D0007544 Zip Gate Opener Fitting

How to fit the zip gate opener to prevent damage to the zip gates

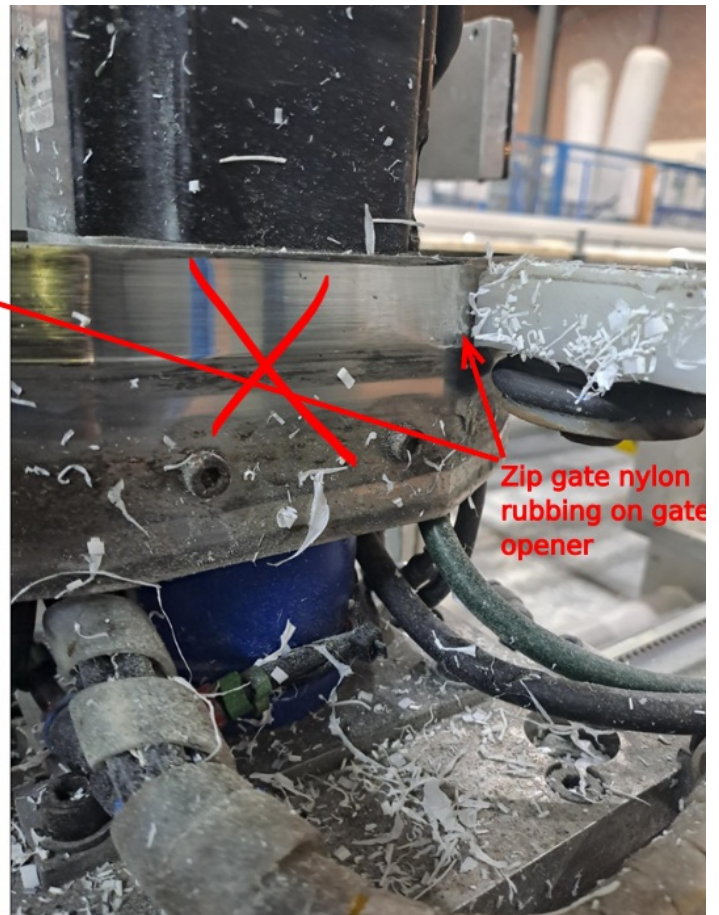
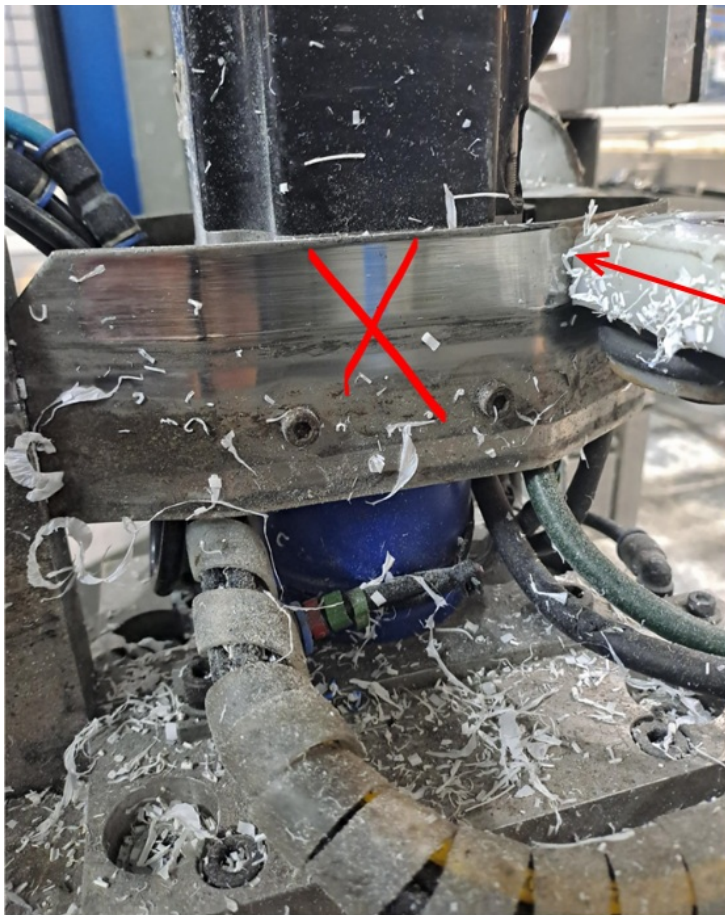
Fitting the Zip gate opener D0007544 upside down will force the plastic to rub on the opener, rather than the rubber roller.

⚠ ...This Part is handed. D0008749 should be fitted for left to right feed machines, or use the latest version D0007544E (unhanded)

D0007544E Redesign

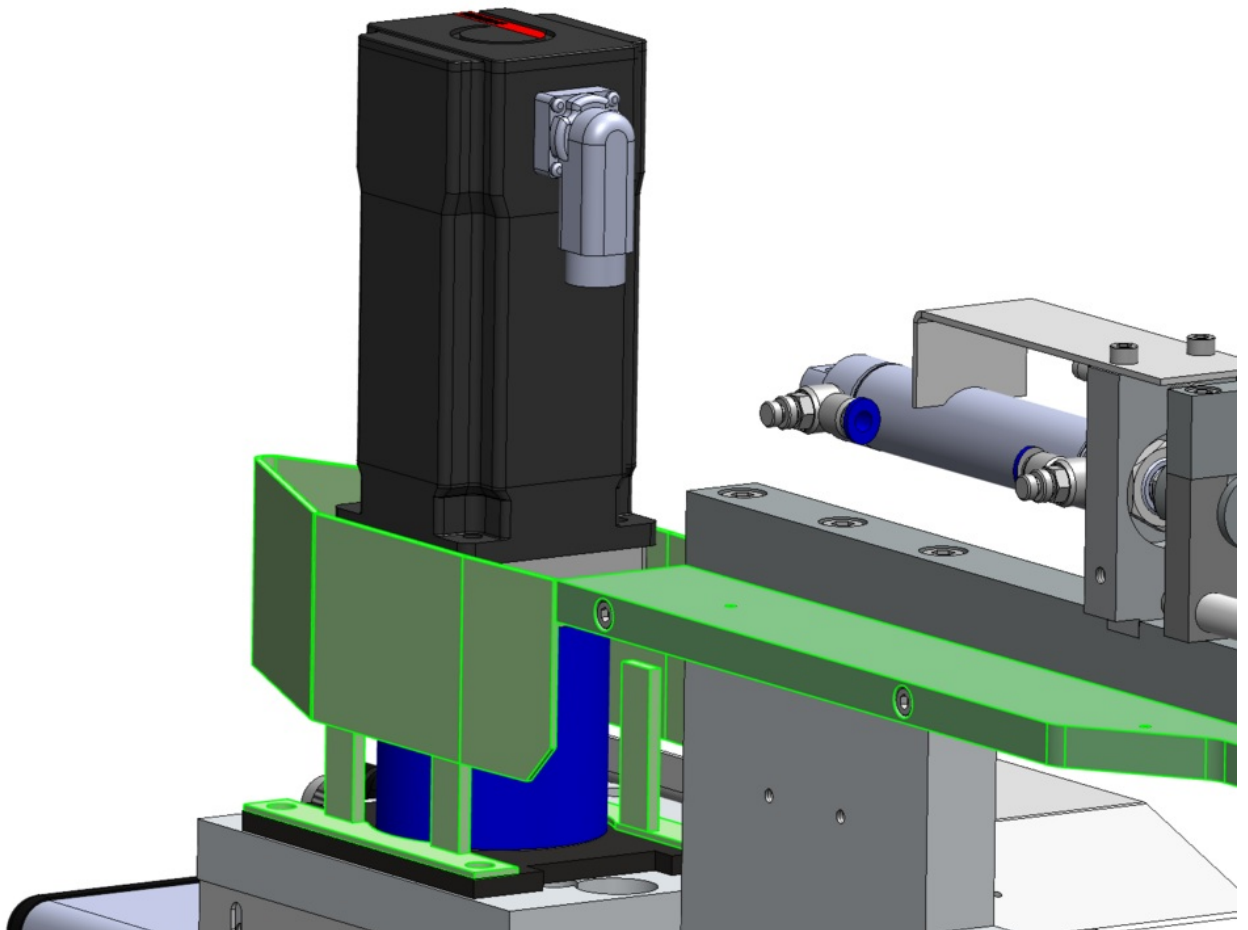
The opener has been redesigned with legs so that the gearbox does not have to be used as a fixing method
This part is **unhanded**
